SERVICE BULLETIN

APPLICABILITY: 2020-23MY Outback
2019-23MY Forester

NUMBER: 03-91-23R

SUBJECT: Clicking/Cracking-Type Sound on Slow Turns
Front Drive Axle Shaft – Design Change

DESCRIPTION OF DESIGN CHANGE:

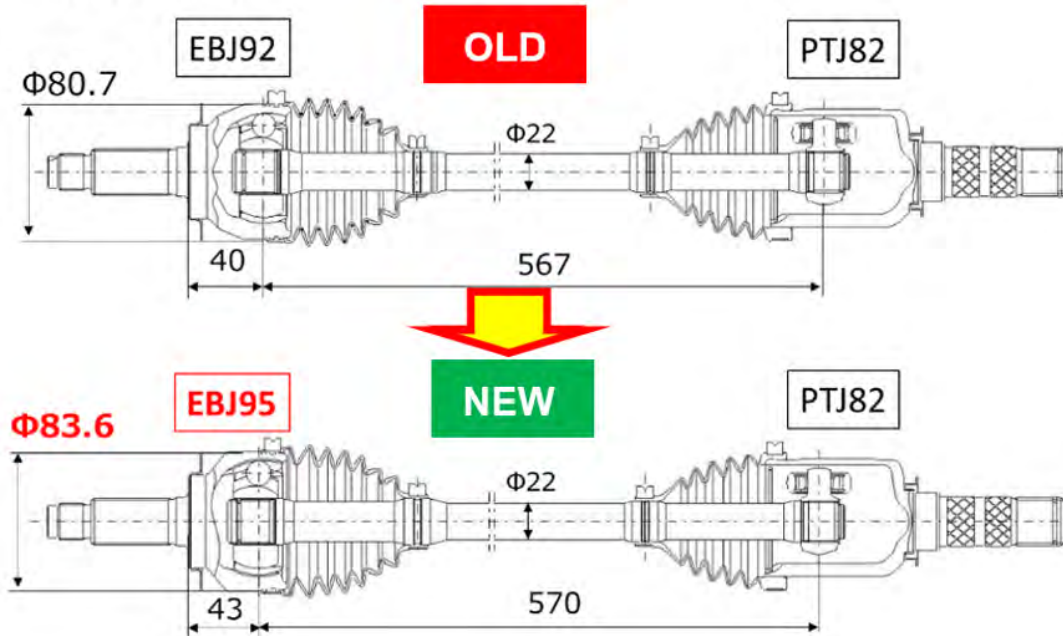
This bulletin announces the design change made to the front drive axle shaft assemblies to address cases of a clicking/cracking-type sound heard when driving with the steering wheel in the fully locked (left or right) position. Size of the joint has been increased to provide added durability. If a clicking/cracking-type sound is duplicated while driving the vehicle with the steering wheel in the fully locked position, replaced the affected side with the newly designed drive axle shaft assembly. The assemblies are not required to be replaced in pairs.

OUTBACK

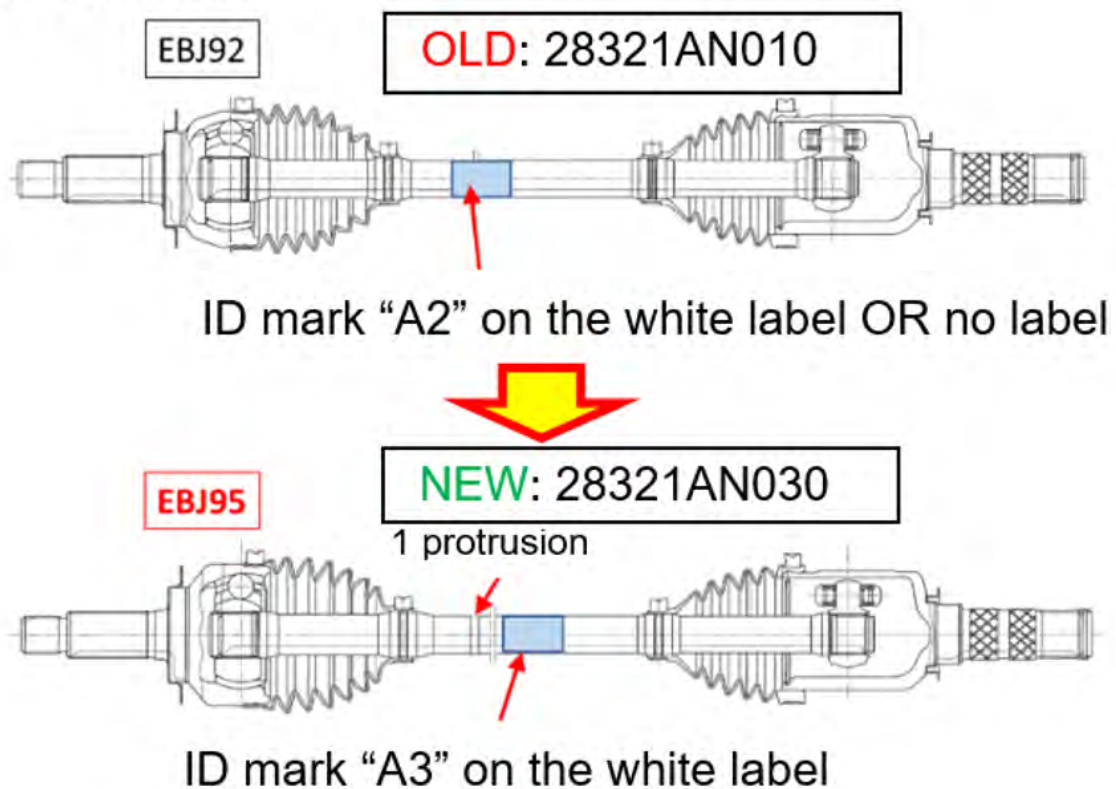
HOW TO DISTINGWITH OLD AND NEW PARTS:

| Model | Part Description | Part Number |
|--------------------|----------------------------|-------------|
| OUTBACK | DRIVE SHAFT ASSEMBLY-FRONT | 28321AN030 |
